# **Technical Bulletin**

911 Carrera 4

Subject: Wiring Diagram Update:
Heater Fan Fuse in Engine Compartment

## 911 Carrera 4, Model Year 1989

Figure 1

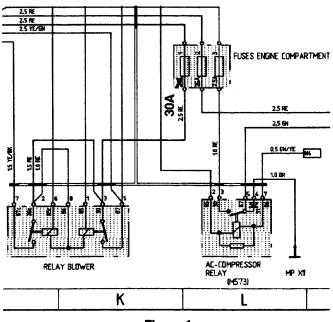
A 30A fuse is required for the heater fan in the engine compartment. This is fuse number 1 on the Fuse/Relay Board in the engine compartment.

Please correct your 911 Carrera 4, Model Year 1989 Wiring Diagrams Sheet 3, Field Coordinate L28 (Figure 1).
